Wellington City Proposed District Plan

Hearing Stream 6 Development Areas:

**Section 42A of the Resource Management
Act 1991**

SUBJECT:**Wellington City Proposed District Plan –
Hearing Stream 6**

3.3.1 DEV2 Mapping

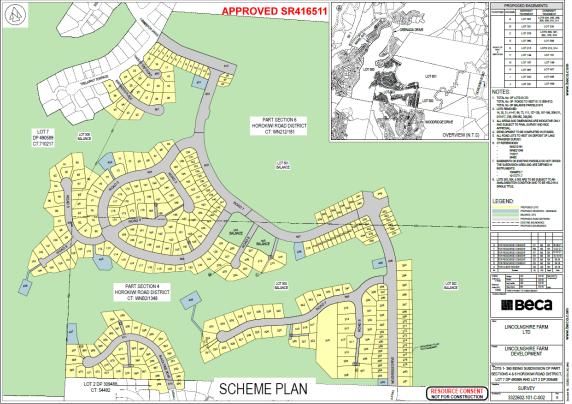
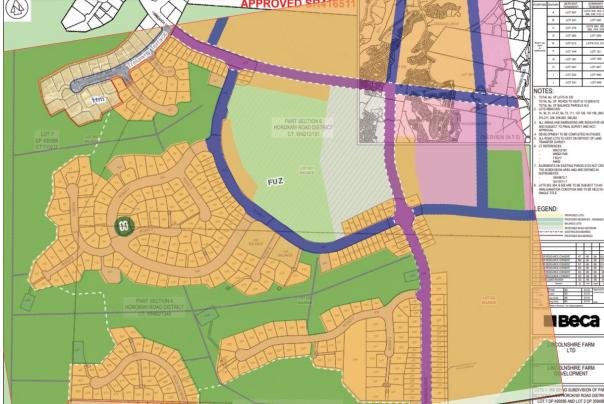
49. WCC [266] opposed by Panorama Property Limited [FS11.34, FS11.35, and FS11.37] seek changes to the Development Plan maps and legends for the purposes of clarification, and better cross-referencing and linkage to the related District Plan appendices, as follow:

- a. [266.40] amend the Development Plan legend to add a letter reference that matches the letters shown on the maps i.e. A – J. The legend should state these letters relate to: ‘neighbourhood park catchment’.

- b. [266.41] amend the Development Plan legend from ‘Neighbourhoodpark’ to ‘Neighbourhood park (approx. location)’ for the purposes of clarification; and

- c. [266.43] amend the map so the location of the letters A – J are moved to be generally in the centre of the white dashed catchment areas.
50. Rod Halliday [submitter 25] has sought a number of amendments to the DEV2 planning maps. Given the volume of amendments sought, for clarity and ease of assessment, I have assessed Mr Halliday’s relief sought and my recommended response in Table 1 below.

51. I agree with Wellington City Council [266.40, 266.41, and 266.43] that the minor amendments will make the PDP clearer.
52. Table 1 below summarises the relief sought by Mr Halliday to amend the DEV2 Development Plan maps and my assessment and recommended response.

53. **HS6-DEV-Rec3:** That the DEV2 Development Plan map be amended as identified in Appendix D.
54. **HS6-DEV-Rec4:** That submission points relating to DEV2 mapping are accepted/rejected as detailed in Appendix B.

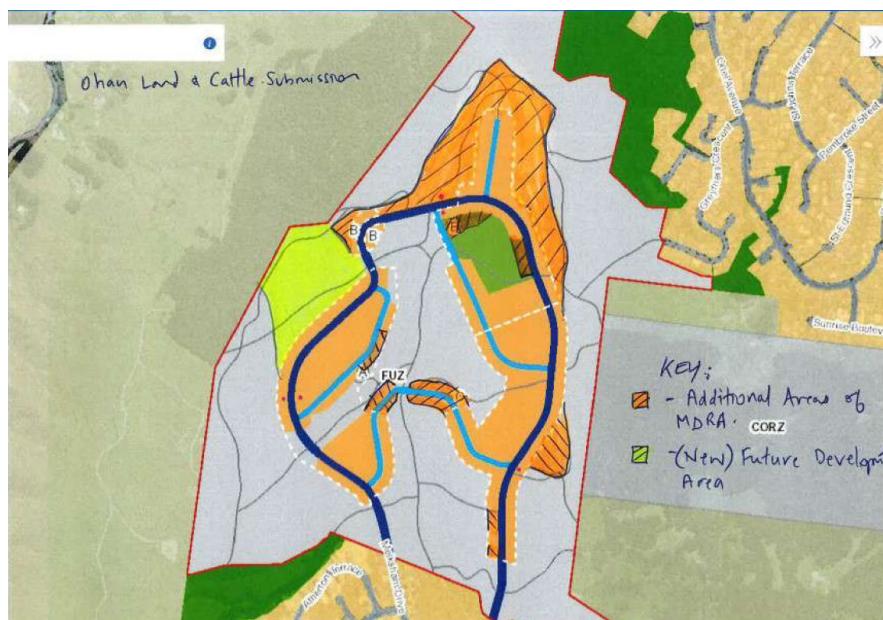
166. WCC [266] seeks changes to the Development Plan maps and legends for the purposes of clarification, and better cross-referencing and linkage to the related District Plan appendices, as follows. These points are opposed by Panorama Property Limited [FS11.34, FS11.35, FS11.36, FS11.37, FS11.38].

- [266.41] amend the Development Plan legend from ‘Neighbourhood park’ to ‘Neighbourhood park (approx. location)’ for the purposes of clarification;
 - [266.42] amend the Development Plan legend from ‘unbuilt area’ to ‘No Build Area’; and deletion of the parentheses that follows: (open space, cut and fill batters);

- [266.43] amend the Development Plan so the letters A – D are moved to be generally in the centre of the white dashed catchment areas.

170. I agree with WCC [266.40] that the absence of the Ridgetop area in the PDP maps was an error. The absence of the mapped Ridgetop area is apparent in **DEV3-R33** (Construction of buildings and structures in the Ridgetop) which makes construction in the Ridgetop area a non-complying activity. This provision relies on the Ridgetop area being identified in the maps. The Ridgetop area also provides clarity for **DEV3-P4.6** "*Protects the natural ridgetop around the Upper Stebbings valley to provide a natural backdrop to Upper Stebbings and Tawa valleys and a connected reserves network.*"

Figure 2: Upper Stebbings – Areas of conflict between additional residential areas and streams or SNAs

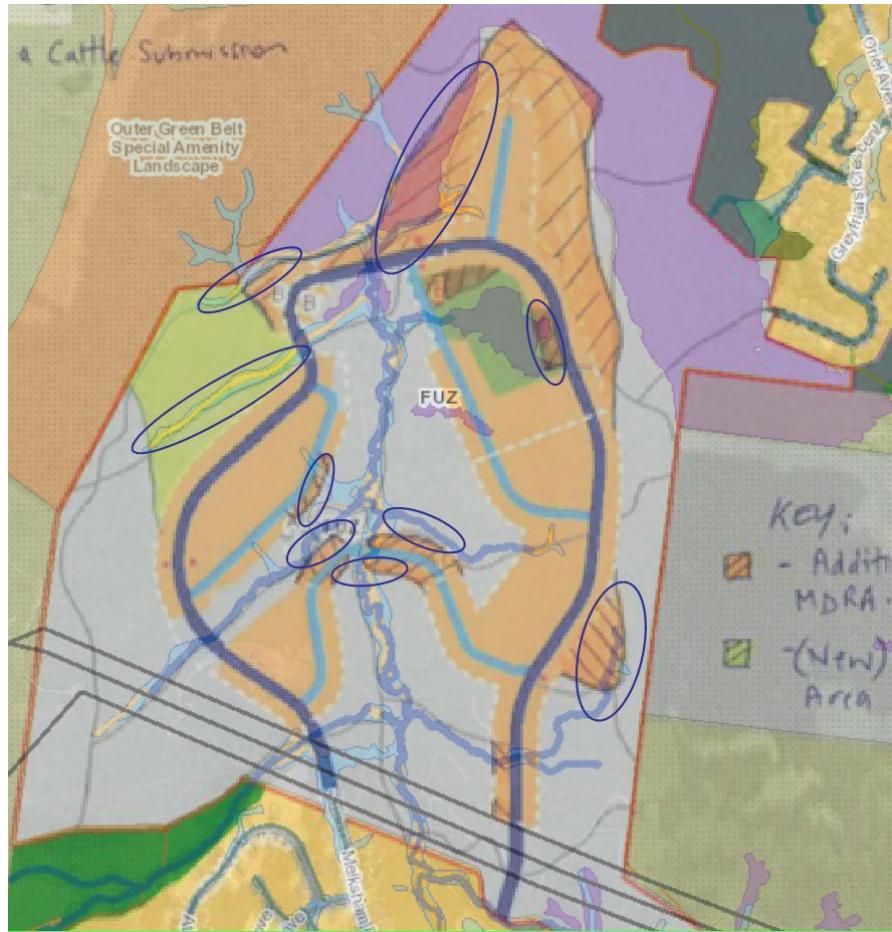
173. The original yield of this Development Area was calculated based on lower densities than those enabled under the RM (Enabling Housing Supply and other Matters) Amendment Act 2021 and associated Medium Density Residential Standards (MDRS). This means that the potential yield of the Build Area within the Development Area has increased and consequentially, the capacity of wastewater and potable water infrastructure needs to be planned accordingly. It does not mean that additional land areas are required to achieve an increased development yield, as argued by the submitter.

Figure 3: Map comparing areas of high visibility with Ridgelines & Hilltops overlay (Boffa Miskell, Upper Stebbings Valley Landscape and Ecology Analysis, July 2018)

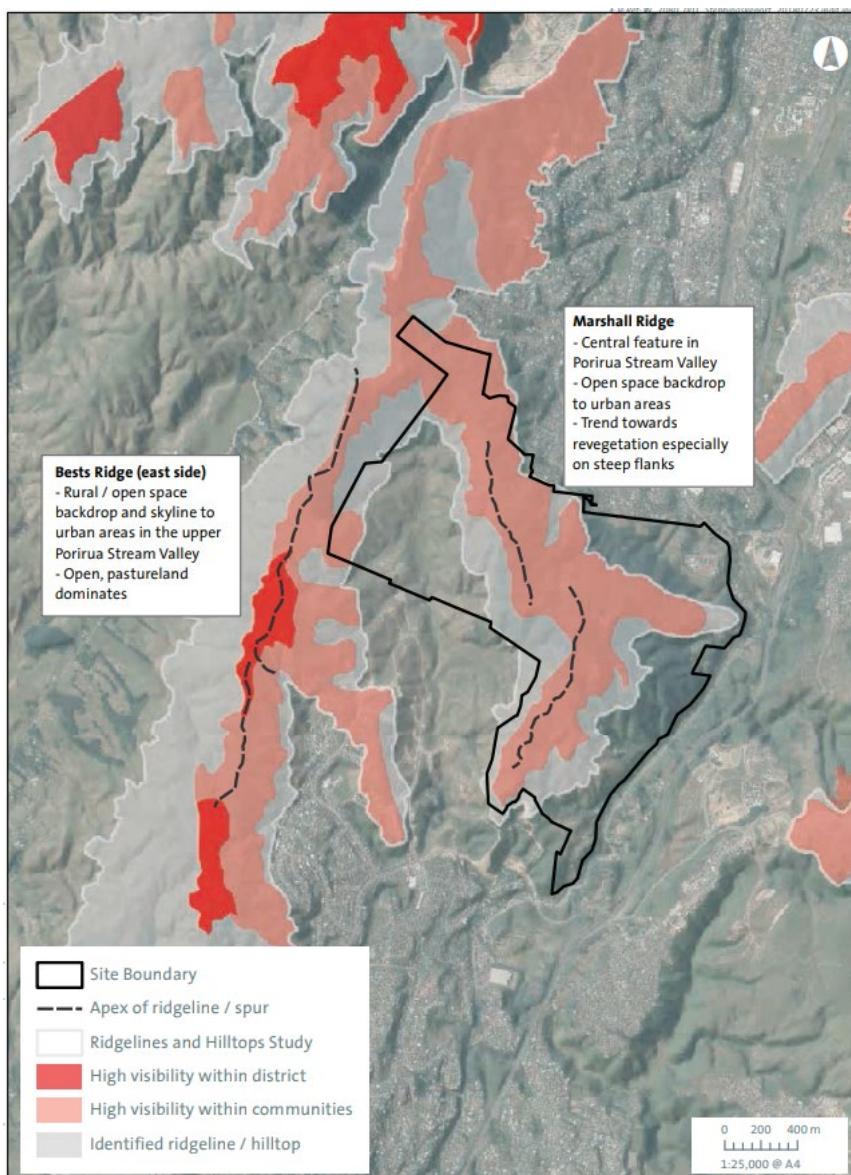
- b. In order to obtain more site-specific information for Upper Stebbings and Glenside West, the Council commissioned Boffa Miskell in 2017 to undertake a more detailed assessment. Figure 3 below, extracted from the Boffa Miskell July 2018 report shows that, on closer examination, some areas of Upper Stebbings and Glenside West identified under the Ridgelines and Hilltops Overlay did not have high visibility either within the communities

- c. The No Build Area within the Upper Stebbings and Glenside West Development Plan includes (but is not limited to) the area identified as Ridgetop in the 2018 Boffa Miskell report. Development within the No Build Area is managed under **DEV3-R32** which makes the ‘construction, alteration of and addition to buildings and structures in the No Build and Natural Open Space Activity Areas’ a discretionary activity.
- d. In addition to being included in the No Build Area, the Ridgetop area is subject to more stringent development provisions under **DEV3-R33** which makes the ‘construction of buildings and structures in the Ridgetop’ a non-complying activity.

Figure 4: Sub-character areas: area 10 is the "Ridgetop" (Boffa Miskell, Upper Stebbings Valley Landscape and Ecology Analysis, July 2018)

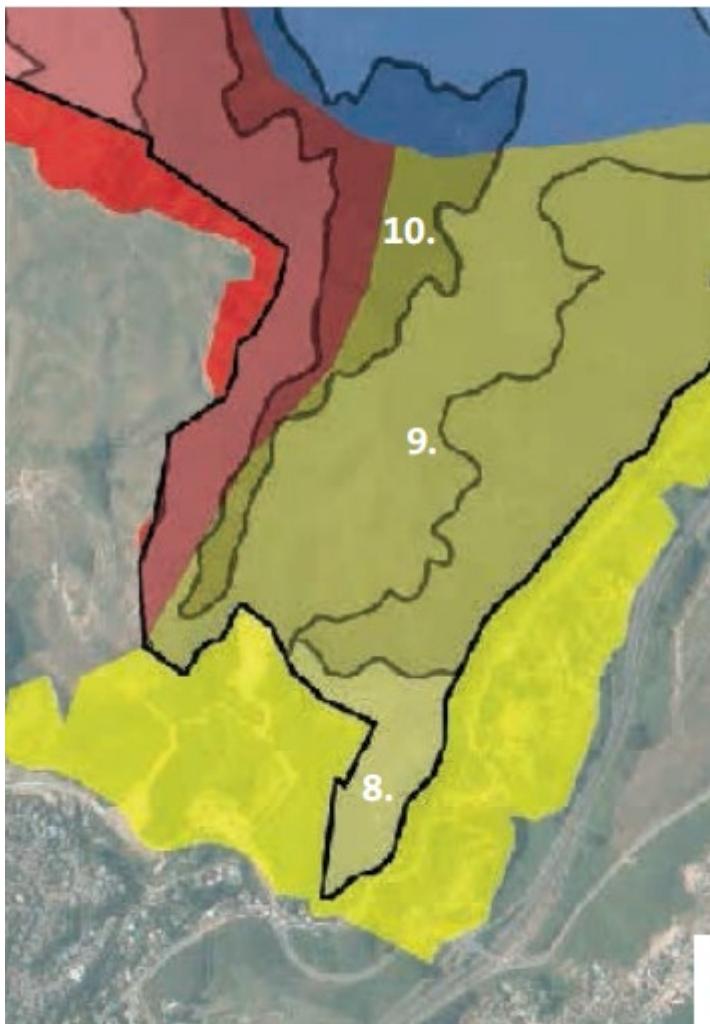
2018 report shows the 'ridgetop' sub-character area around Marshall Ridge, identified as area 10 in Figure 4:

214. Overall, I consider the notified rule framework, as well as amendments recommended as part of Hearing Stream 5, and recommended amendments to **DEV3-O4** address the concerns of submitters as to the protection of Marshall Ridge.

Figure 5: Churton, Bridgetown, Grenada Development (Wellington City Corporation, 1976)⁵⁶

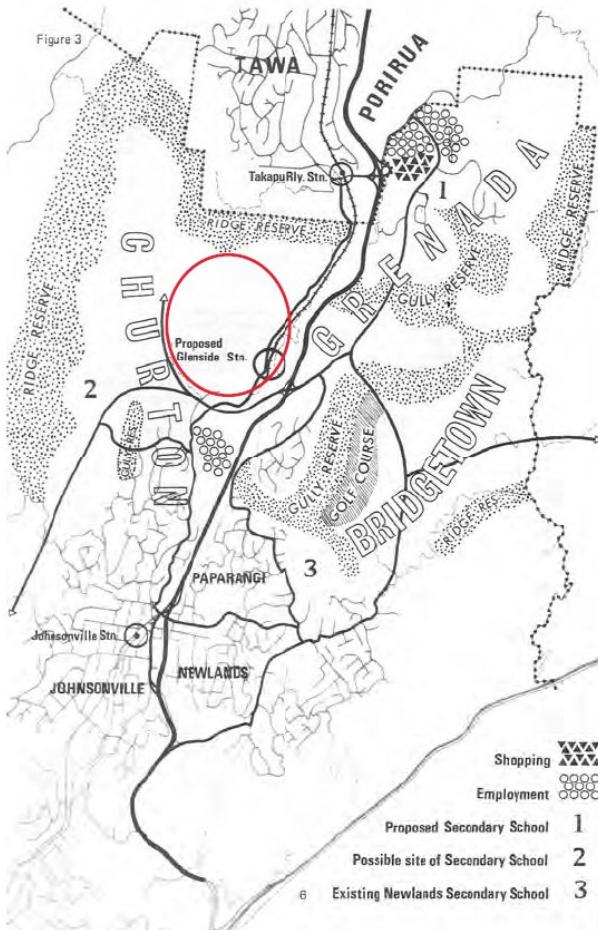
220. In response to Glenside Progressive Association [374.7 and 374.8], I consider that the statement in the notified introduction is correct as it reflects the identification of Glenside (and a new Glenside train station) as a development area in the 1976 Churton, Bridgetown, Grenada Development (Wellington City Corporation) plan. Glenside West is circled in Figure 5 below. That said, I do not consider that the sentence adds materially to the Chapter and, to remove a point of contention, I recommend the sentence be deleted.
